CITY PLAN COMMISSION STAFF REPORT

Project Name Promise Place

Docket #6/ Case # Request
.1 - CD-CPC-2022-00084 – Area Plan Amendment.
.2 – CD-CPC-2022-00086 – Rezoning with plan

Plan Conditions

1/8" = 1'-0"

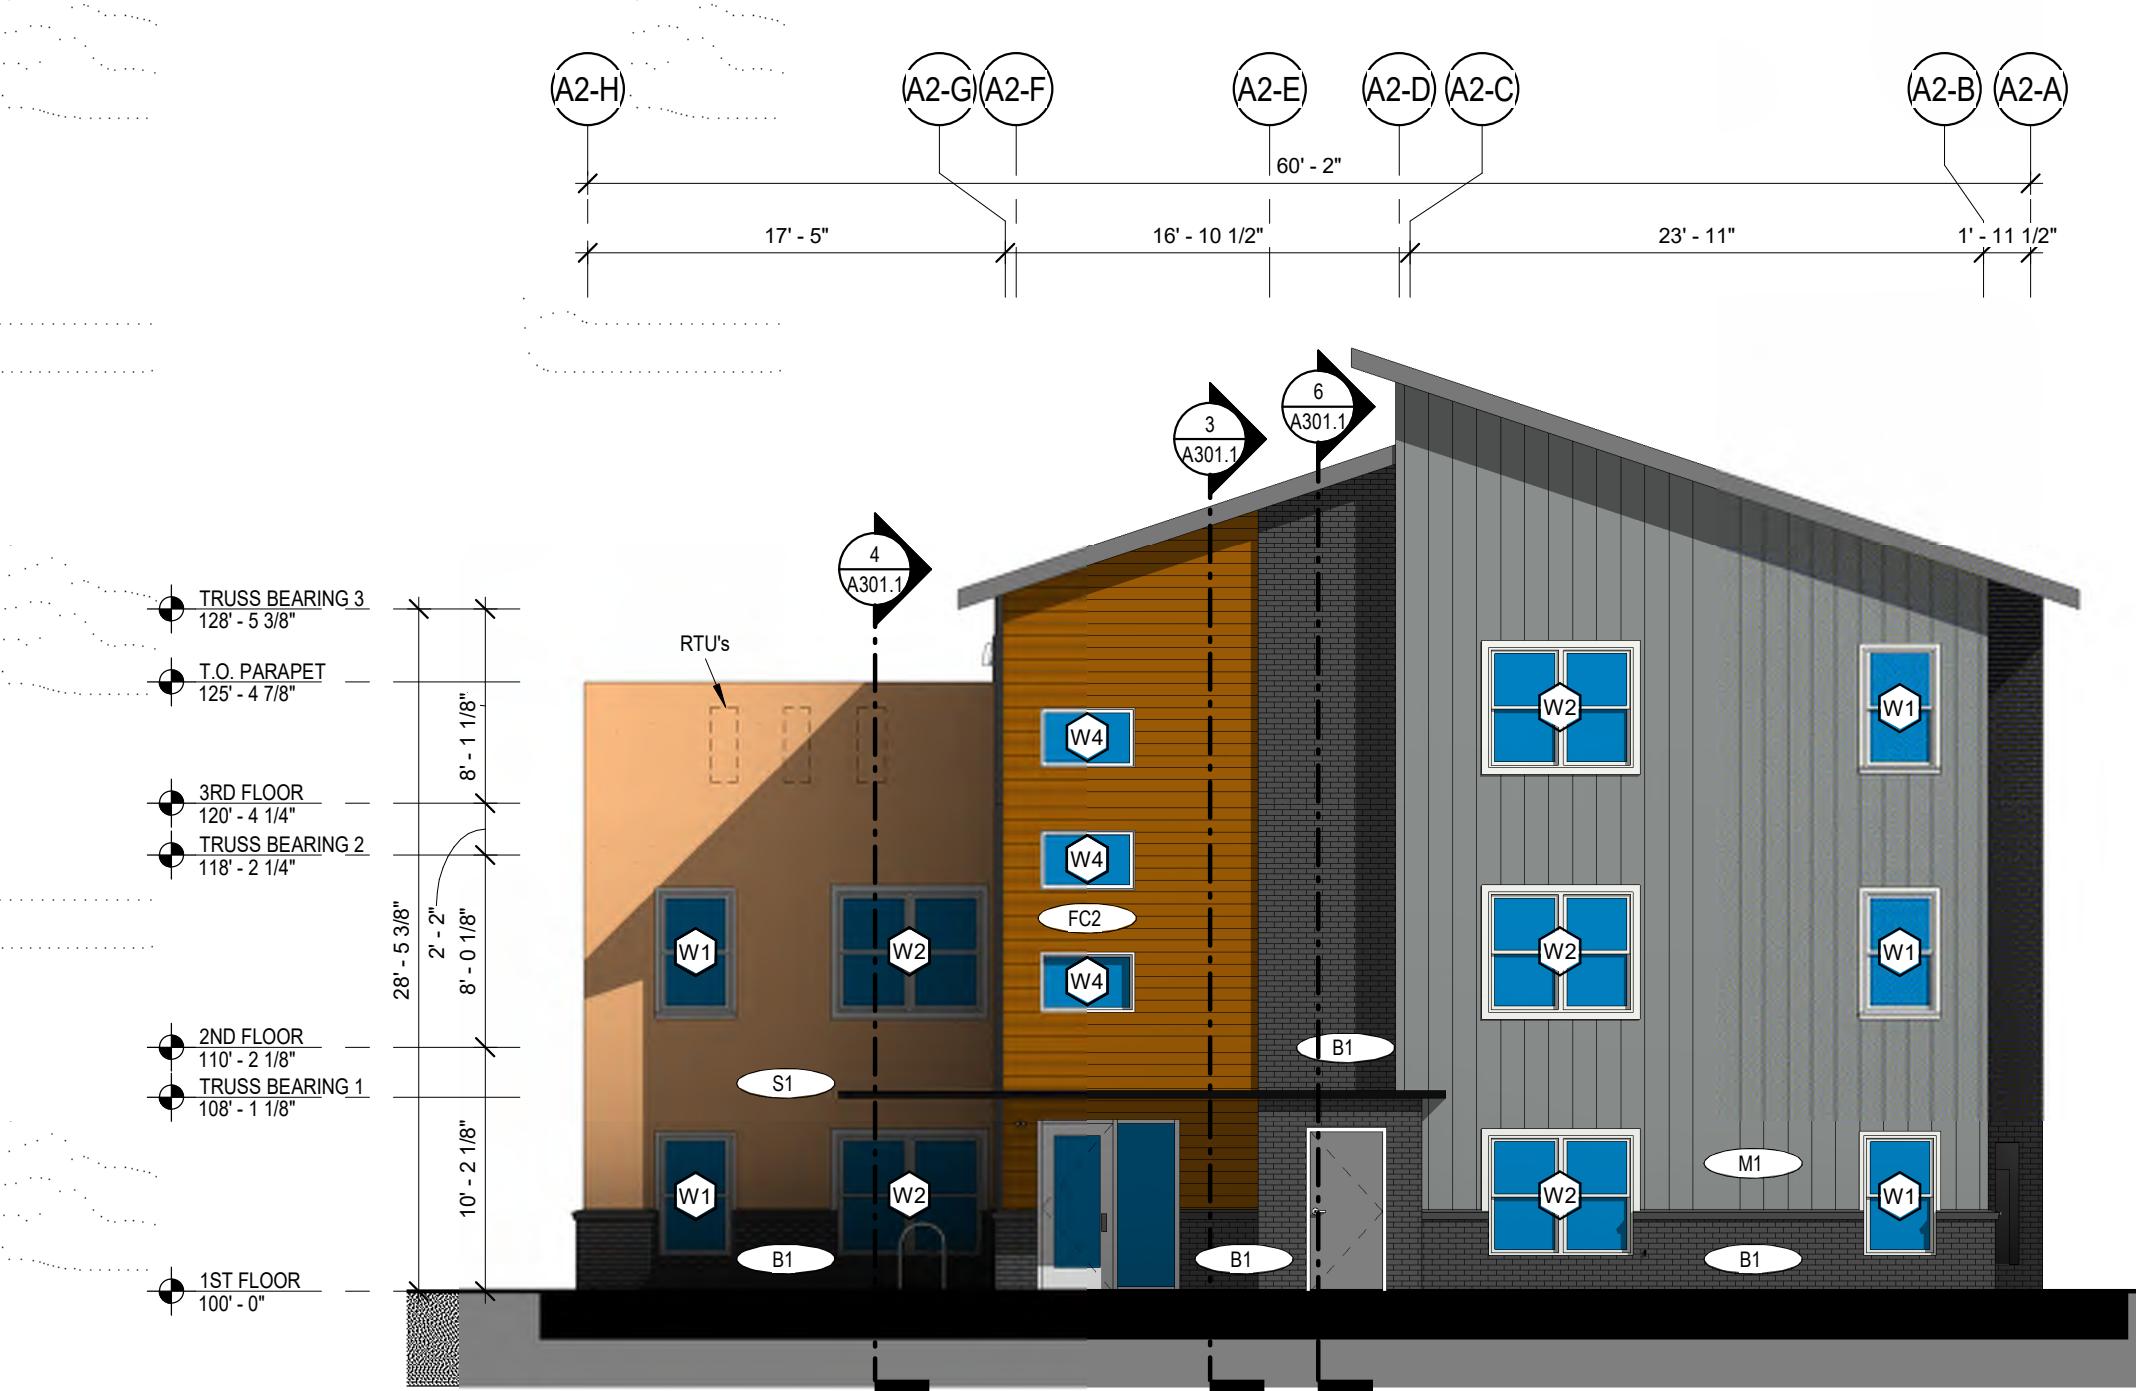
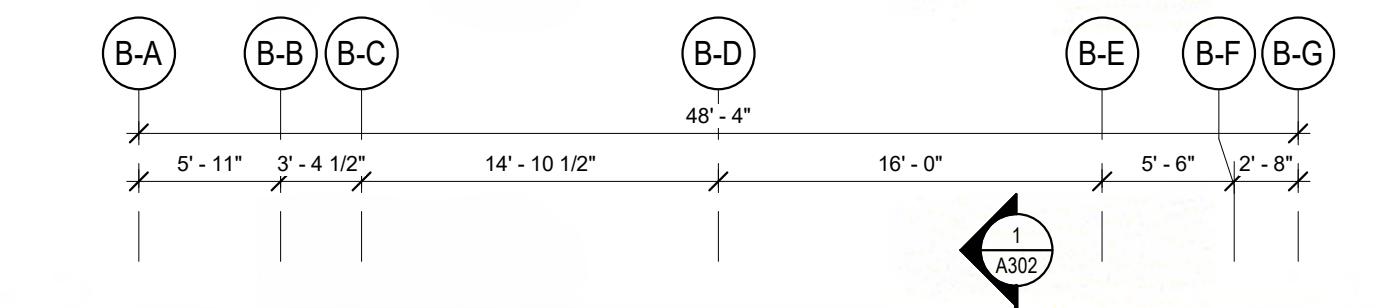
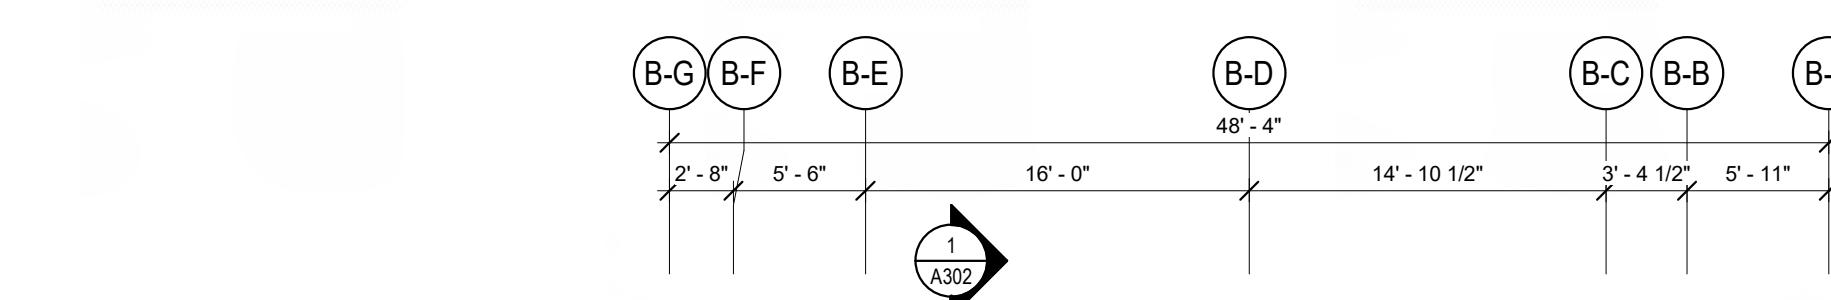
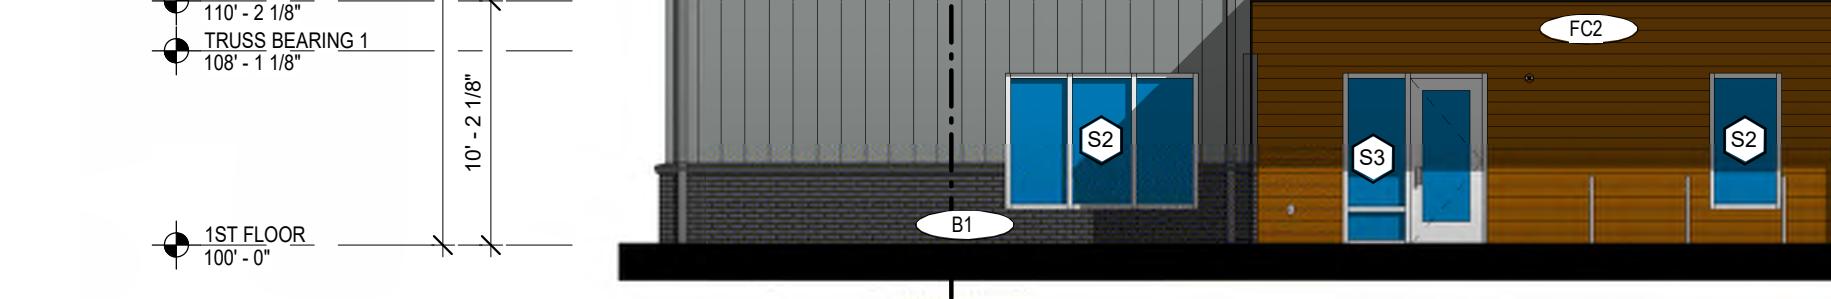
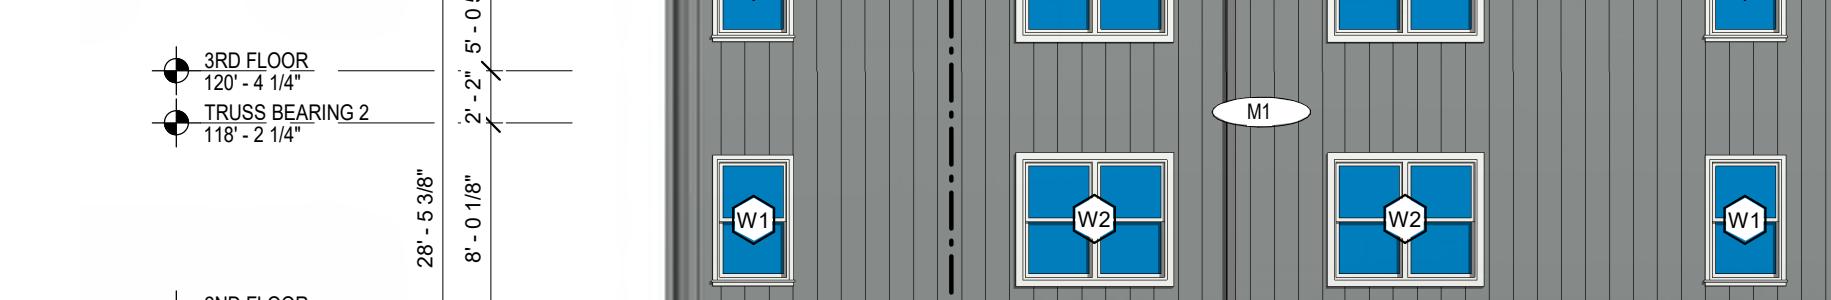
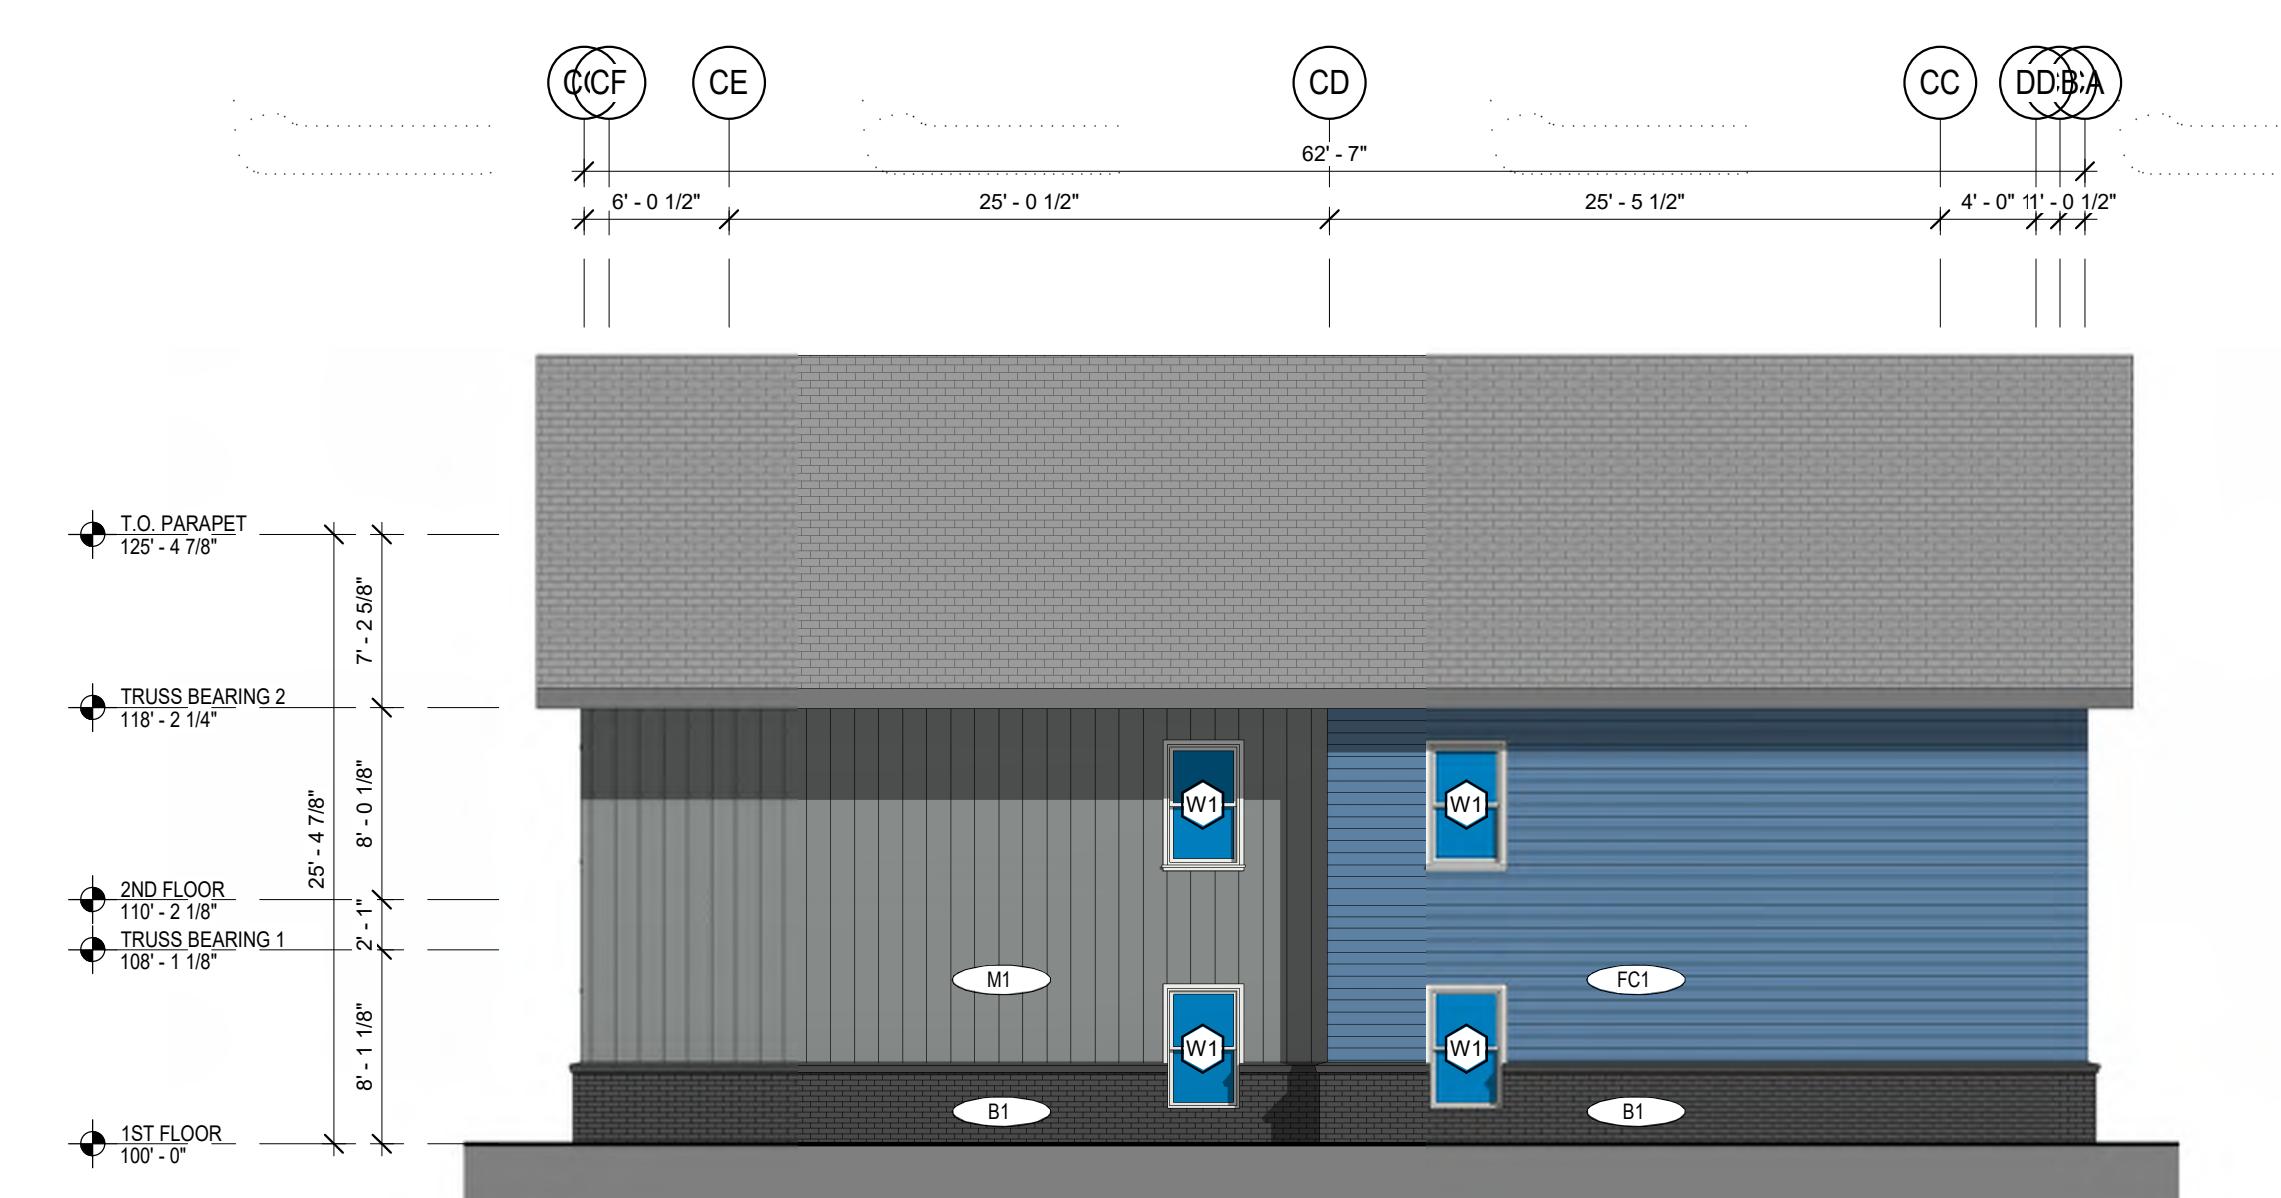
Staff was concerned about the initial building elevation that shows blank walls that face the public street or public sidewalk. Staff recommended that the building elevations be revised to provide a primary entrance for each building facing and directly accessible from the public street and a secondary entrance for each building facing the parking courtyard. Staff also recommended that the pedestrian circulation system that connects residential entrances to adjacent public right-of-way (sidewalks) and to parking area. Other comments require that the developer create open space for amenities for the residents. The applicant has met with staff and submitted the accompanying revised plan addressing most of the attached corrections and conditions. As a result, the corrections will be revised prior to ordinance request.

5. That the developer continue to work with staff to ensure that the building elevations and design meet the requirement of the Zoning and Development Code and the recommendations of the design guidelines of the the Heart of the City Area Plan prior to City Council action.
6. The developer shall submit an affidavit, completed by a landscape architect licensed in the State of Missouri, verifying that all landscaping required of the approved plan has been installed in accordance with the plan and is healthy prior to Certificate of Occupancy.
7. That all signage shall conform to 88-445 and shall require a sign permit prior to installation.
